OFFICIAL ANNOUNCEMENT
Product Change Notification

PCN #: PCN022

Synopsis: New Enclosure for L-TERM / Neues Gehäuse für L-TERM

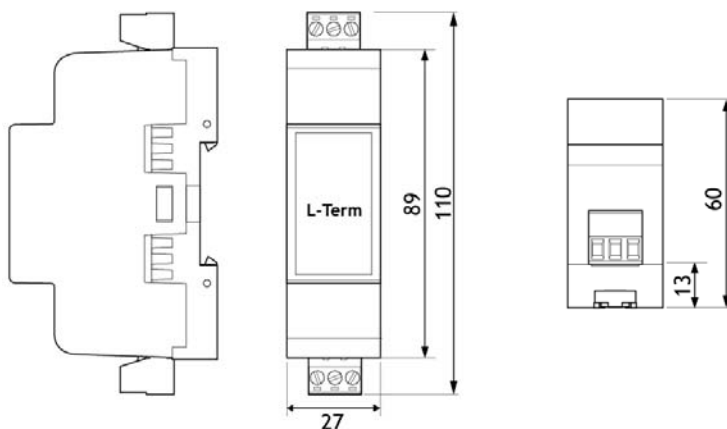
The enclosure of the product will be changed. The connectors will be replaced with pluggable connectors. The new enclosure has a much better flammability rating of UL 5VA. The new enclosure is a full replacement in form, fit and function with a slightly wider enclosure. The width of the new enclosure is 27mm compared to 17.5mm of the current enclosure.

Please update your documentation with new enclosure dimensions.
